## COLERAIN TOWNSHIP BOARD OF ZONING APPEALS

Staff Report: Board of Zoning Appeals  
Case# BZA2018-009  
Variance Request: Non-Conforming Sign  
Location: 7671 Colerain Ave.  
Meeting Date: August 22, 2018  
Prepared by: Marty Kohler  
Senior Planner

Staff Report: Board of Zoning Appeals  
Case# BZA2018-010  
Variance Request: Room Addition Setback  
Location: 10140 Colerain Ave.  
Meeting Date: August 22, 2018  
Prepared by: Marty Kohler  
Senior Planner

Staff Report: Board of Zoning Appeals  
Case# BZA2018-011  
Variance Request: Privacy Fence  
Location: 3598 Ripplegrove Dr.  
Meeting Date: August 22, 2018  
Prepared by: Jesse Urbancsik, Planner

**SHEET NO. Z1**

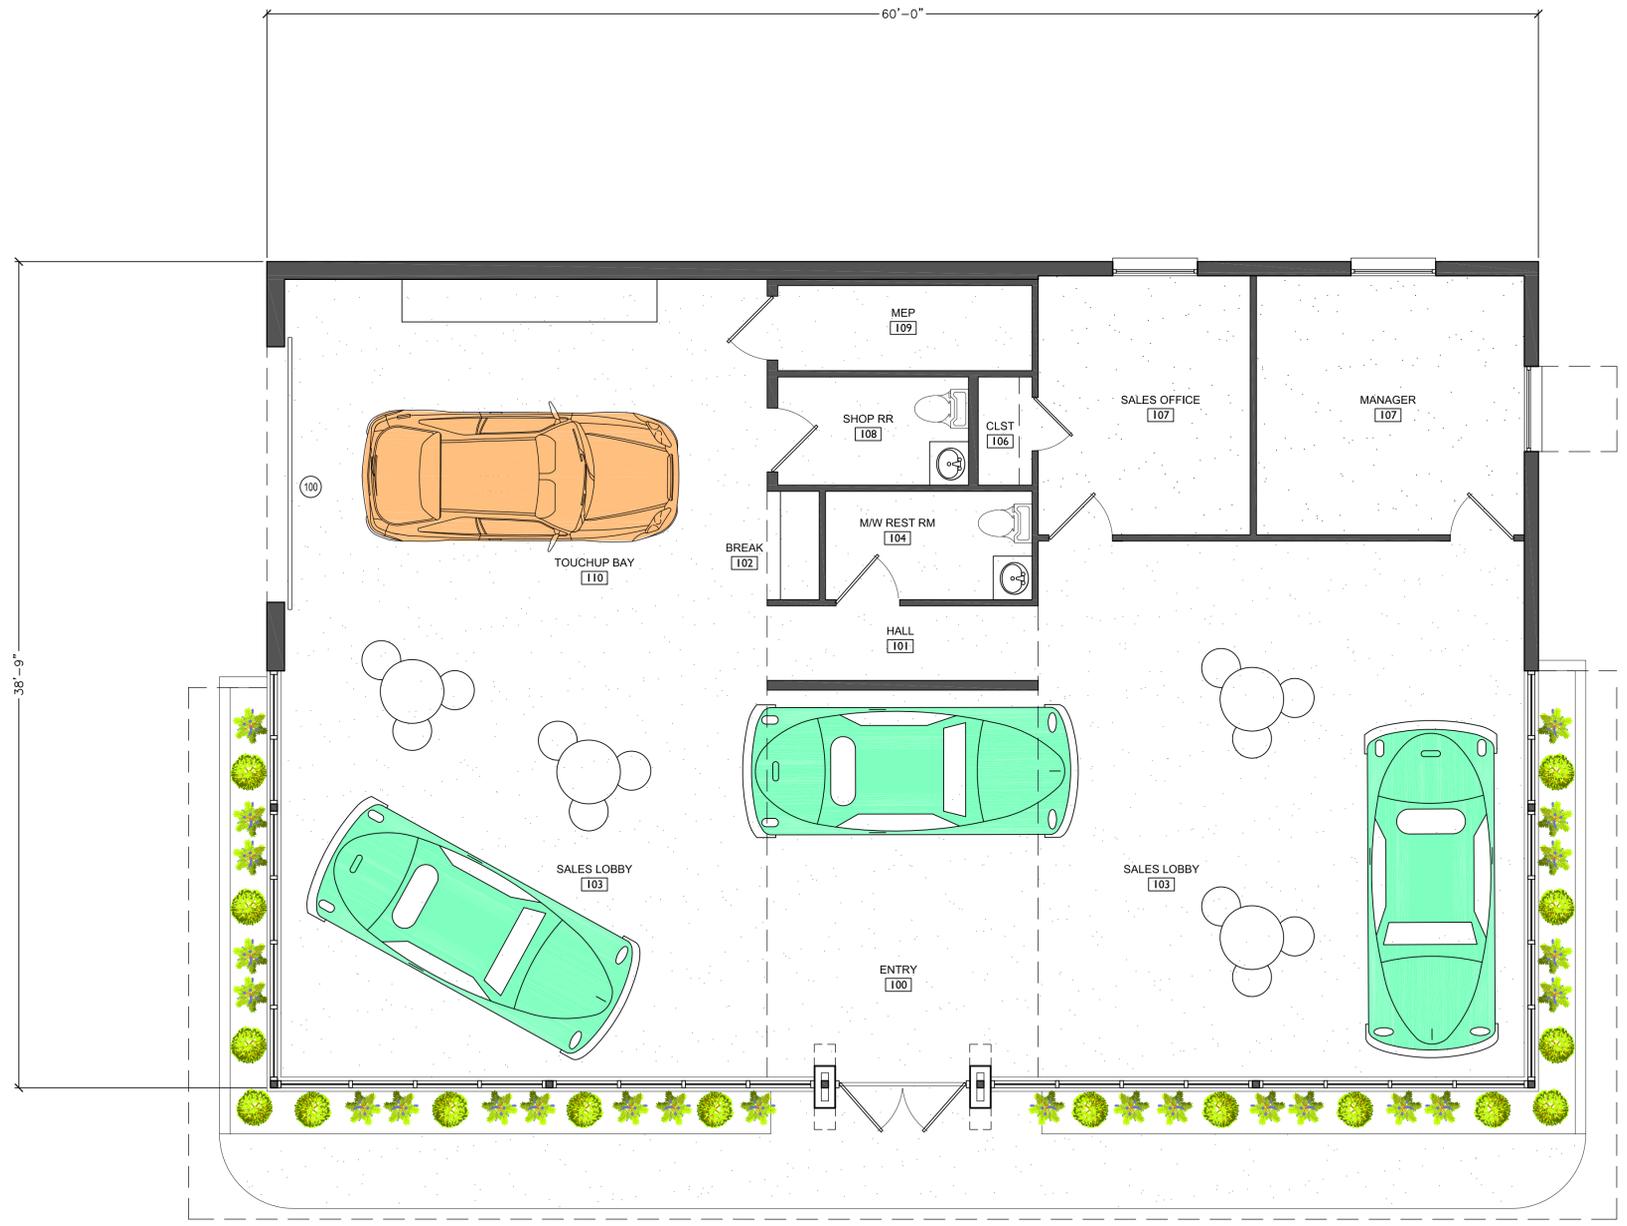
Section 8.3.1 – The minimum lot area in the B-2 zone is 1 acre. The plan indicates a net lot area of 0.33 acres. The variance request is for a 0.67 acre reduction from the minimum lot area.

Section 8.3.1 - The maximum lot coverage by impervious surfaces is 75 percent. The site plan indicates a lot coverage of 87 percent. The variance request is for an additional 12 percent of the site to be covered with impervious material.

Section 13.4.2(D) – The minimum setback for parking spaces on entries perpendicular to the right of way is 30 feet. The actual setback is 18 feet on the north and south property lines. The variance request is for a 12 foot reduction in the setback for perpendicular parking.

Section 14.6.1 - The minimum area for landscaping of a parking lot is 15% of the total area. No internal landscaping is proposed. The variance request is for the elimination of this requirement.

Section 14.6.2(A) - A landscape island is required at the end of each row of parking including the parking along the street frontage. None are proposed. The variance request is for the elimination of this requirement.

Section 13.4.1 and 15.5.1 requires that the parking area have a 15 foot setback from the right-of-way and that the setback include landscaping. No setback of the parking from the right-of-way is proposed. The variance request is for the elimination of this requirement.

Section 13.4.2(C) requires a pedestrian connection between the building customer entry and the public sidewalk along Colerain Ave. None is proposed. The variance request is for the elimination of this requirement.

- ii. Section 8.3.1 the maximum lot coverage by impervious surfaces is 75%.
  - 1. As indicated on Z1 of our drawings, the percentage of impervious pavement is 82%, not 87% as indicated in your refusal letter.
  - 2. The Car Connections property after the roadway project is no longer a grandfather parcel and does not meet the maximum lot coverage by impervious surfaces for the B-2 Business Zone.
  - 3. The site will be used as it was before the roadway project occurred with a similar percentage of impervious to pervious lot coverage.
  - 4. Car Connections requests a variance to the maximum lot coverage by impervious surfaces as indicated on the submitted site plan of 7% from 75% to 82%.

- vi. Car Connections requests a variance to the minimum parking setback requirements as indicated on the submitted site plan from 30 feet to 18 feet.

- c. Section 14.6.1 – Minimum area for landscaping of a parking lot is 15% of total area.
  - i. The Car Connections property after the roadway project is no longer a grandfather parcel and does not meet the minimum landscape requirements for the B-2 Business Zone.
  - ii. Before the roadway project the Car Connections site did meet the minimum landscape requirement.
  - iii. Car Connections requests a variance to the minimum parking lot landscape requirements as indicated on the submitted site plan from 15% to 13%.

- f. Section 13.4.1 & 15.5.1 requires that the parking area have a 15 foot setback from the right-of-way and that the setback include landscaping.
  - i. The Car Connections property after the roadway project is no longer a grandfather parcel and does not meet the minimum buffer requirements for the B-2 Business Zone.
  - ii. Before the roadway project the Car Connections site did meet the minimum requirement for the 15 foot landscape buffer.
  - iii. After the roadway project that area was removed from the property. The property no longer has the depth need to provide a full 15 foot deep buffer area, the required parking, and the relocated building.
  - iv. Car Connections requests a variance to the minimum landscape buffer requirement as indicated on the submitted site plan from 15 feet to 0 feet.
